Supersession Tensioner Pulley 531 0069 10 and 531 0071 10 by 531 0250 10

Engine: J8S 2.1 D, 2.1 TD

LuK AS Part No.: 531 0250 10

Fig. 1: View of the replacement

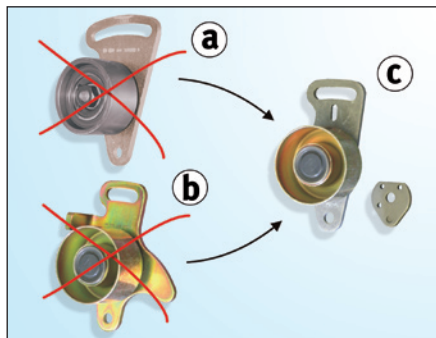
The two tensioner pulleys **531 0069 10** and **531 0071 10** are no longer available and have been replaced by tensioner pulley **531 0250 10** (see **Fig. 1**).

The tensioner pulley **531 0250 10** is in two parts:

- Tensioner pulley with base plate
- Distance plate

- a) Tensioner pulley 531 0071 10
- b) Tensioner pulley 531 0069 10
- c) Tensioner pulley **531 0250 10**

Fig. 2: Drive overview

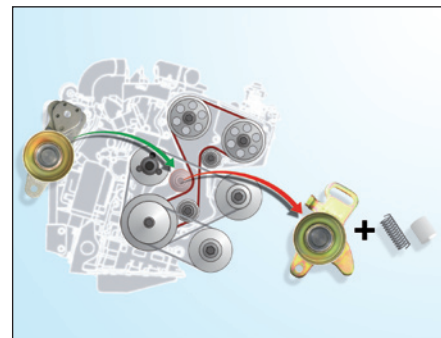
1. Position the engine as directed by the manufacturer
2. Remove the old tensioner pulley (the spring and sleeve are **not** required)
3. Fit the new tensioner pulley (the old bolts can be re-used)
4. Tension the timing belt with a suitable tool
5. Tighten down the mounting bolts according to the manufacturer's directions
6. Turn the crankshaft by hand two
7. turns in the engine's direction of rotation
8. Check the tension of the timing belt with a suitable tester and adjust as necessary (repeating steps 4 to 6)
